Dart Aerospace Ltd. Thursday, 11/9/2006 4:37:15 PM User: Kim Johnston **Process Sheet** : SADDLE, OUTBOARD, RH, 206 : CU-DAR001 Dart Helicopters Services **Drawing Name** Customer Job Number : 29389 : 10523 **Estimate Number** : D26652 Part Number Al4: P.O. Number : D2665 REV. C S.O. No. : NIA **Drawing Number** : 11/9/2006 This Issue : N/A **Project Number** Prsht Rev. : N/A : MACHINED PARTS **Drawing Revision** First Issue Type : 28602 Material **Previous Run** Each : 11/28/2006 Qty: 12 Um: **Due Date** Written By Checked & Approved By Removed P/O for Powder Coat - in Comment house process EC **Additional Product** Job Number: Description: Seq. #: Machine Or Operation: 7075-T7351 2X6.25X7.875 D6101003 1.0 Comment: Qty.: 12.0000 Each(s) 1.0000 Each(s)/Unit Total: 7075-T7351 2X6.25X7.875 Grain Along Long 7.88 Length Cut Size 2.0" x 6.25" x 7.88" HAAS1 2.0 Comment: HAAS CNC VERTICAL MACHINING #1 1- Program batch number ( 2- Machine Step # 1 of Folio and visually inspect as per attached Dimension Sheet 3- Machine Step # 2 of Folio and visually inspect as per attached Dimension Sheet 4- Machine Step # 3 of Folio and visually inspect as per attached Dimension Sheet 5- Deburr MILLING CO

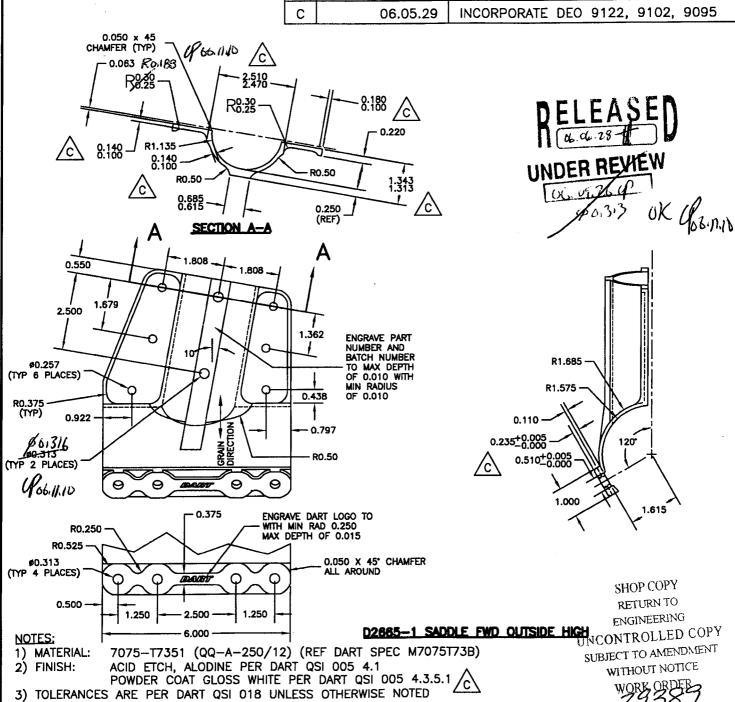
On attach saddle drawing, according to Eric the marked-up radius that reads 0.30 and 0.25, should be 0.188 since the tooling has been changed long time ago, and apparently they have been machining those radiuses to 0.188 for a while. Do you see a problem with that? if not I will go ahead and change the drawing to reflect the changes.

The two 0.313 OD saddle-to-crosstube holes, the dwg says 0.313, the folio is evidently calling for a 0.316 drill. The 0.316 is required to fit the part on the tooling, they must have been using 0.316 for some time. Anyhow, they want the drawing changed to 0.316 (I don't see a big problem with that), but for now they need an email to sign of this latest batch as a deviation on the work order. Ultimately this would affect all the 206 saddles. Is 0.316 OD acceptable for the saddle-to-crosstube holes on the D2665 saddles?

Change the drawings. I guess we will also change the 0.313 crosstube hole dimensions as well. See D2661 to D2668 as well as D2932 to D2933.

This is acceptable.
